Ref: 8411197

RE: Application No. 2-14-1340 – Response to Letter of August 28, 2014

PILLAR POINT HARBOR

WEST TRAIL CULVERT REPAIR

2 IMPROVEMENTS SITE PLAN

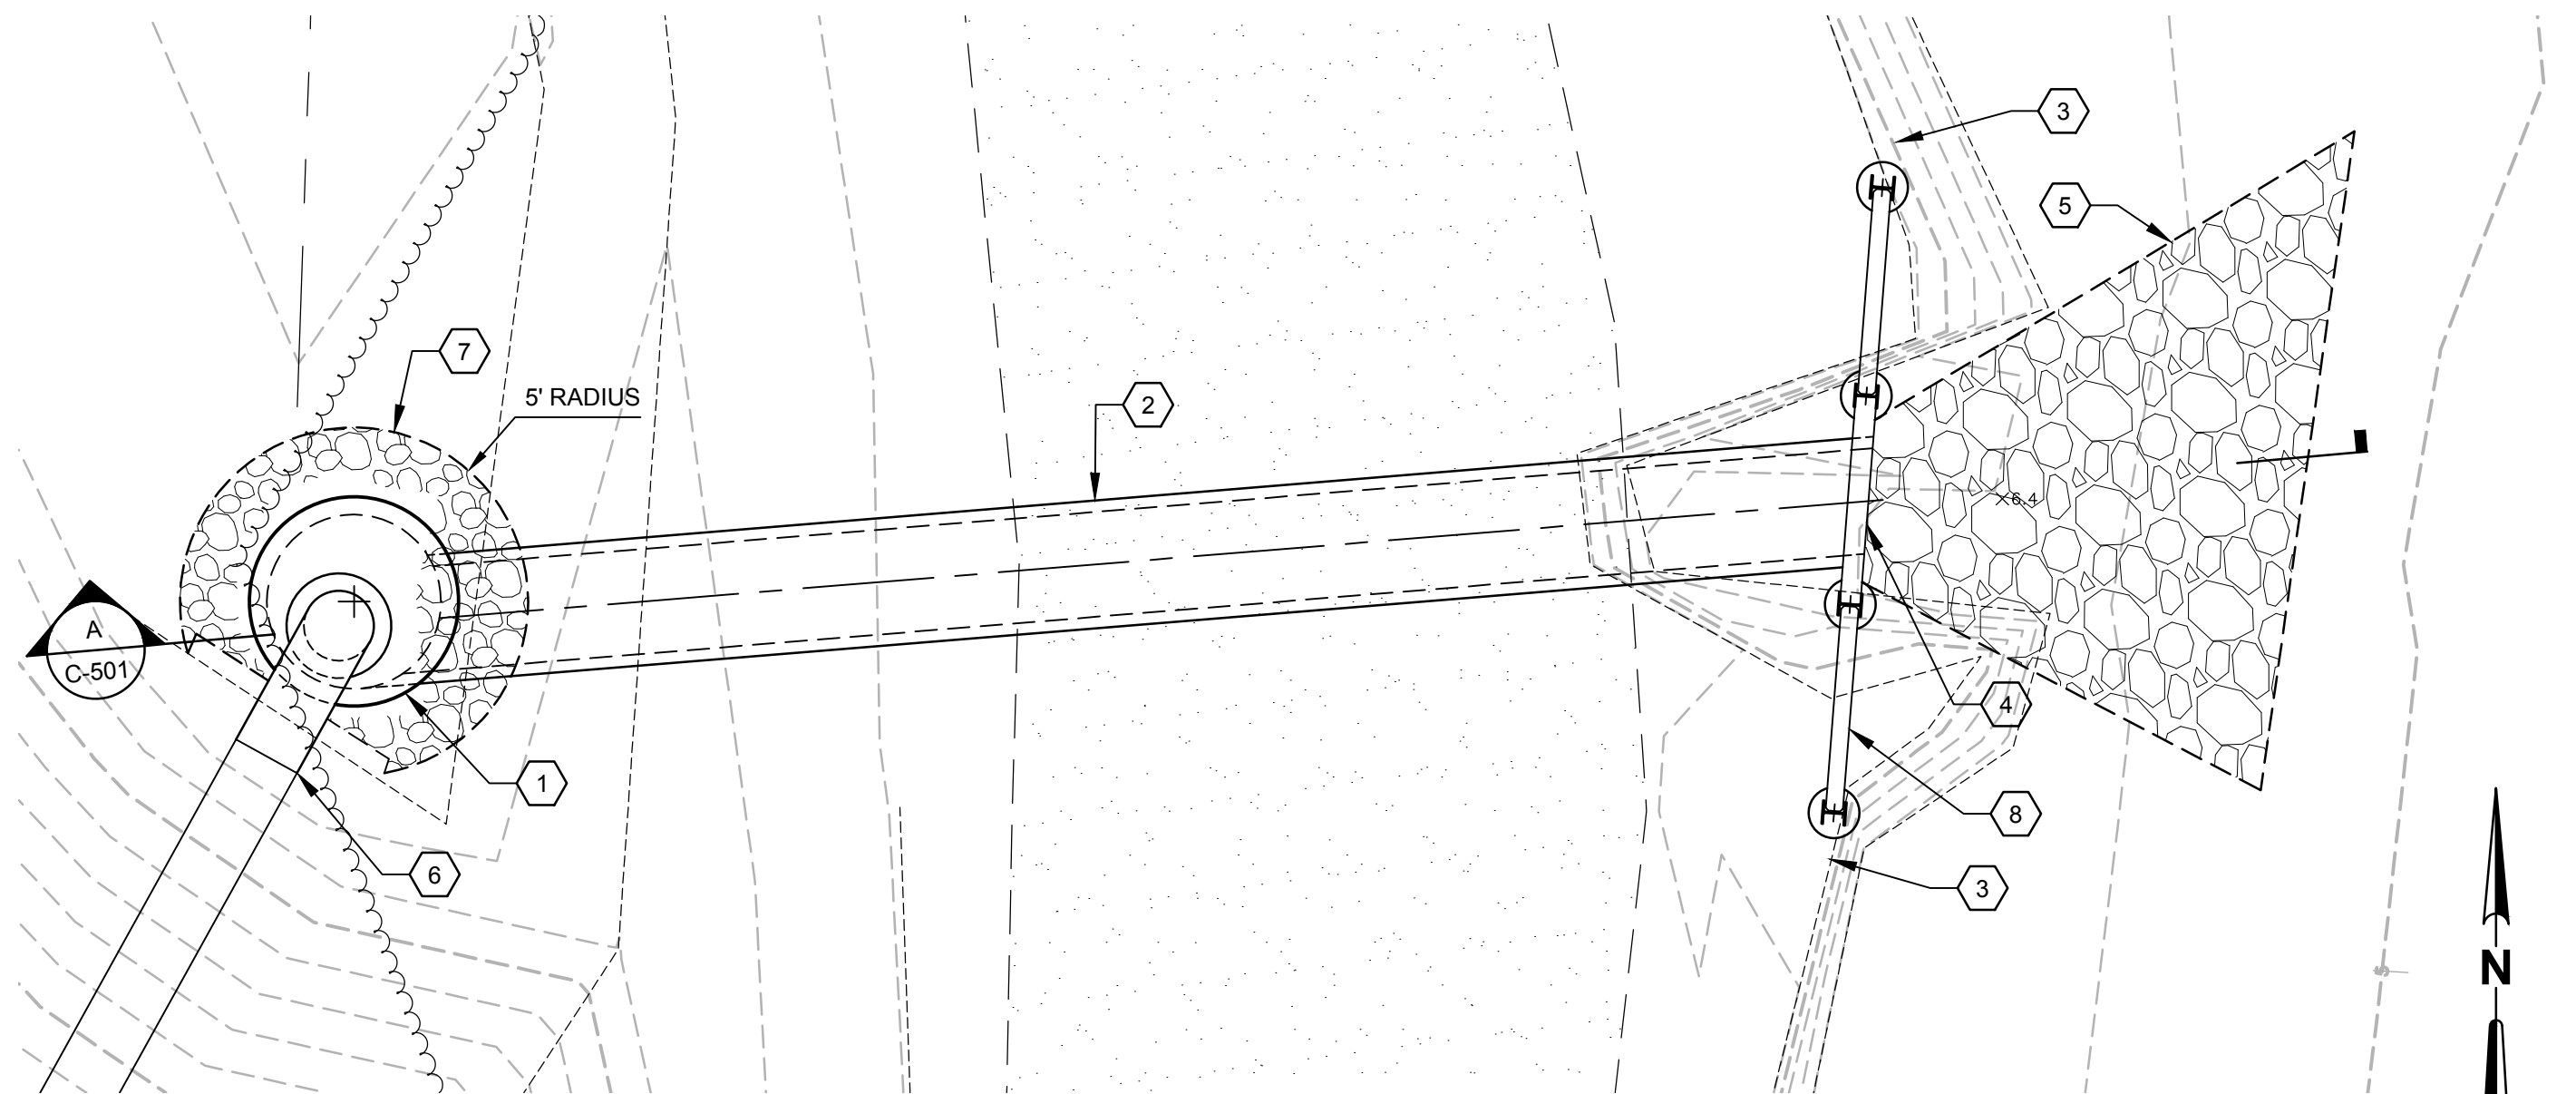
5. **Inconsistencies in Application.** *Item 8 on page 3 of the application says that no grading is proposed for the project. However, Keynote 3 on item 2 of drawing C-501 refers to grading of the hillslope. Please clarify this discrepancy.*

No grading is proposed. The eroded shoreline would be recontoured where it meets the soldier pile wall to match and conform to existing grade. The updated plan sheet is included with this application.

3. RECOUNTOUR EMBANKMENT FACE AT NEW WALL ENDS TO MATCH AND CONFORM TO EXISTING GRADE.
4. INSTALL TIDEFLEX SLIP-IN STYLE INLINE CHECKMATE CHECK VALVE OR APPROVED EQUAL.
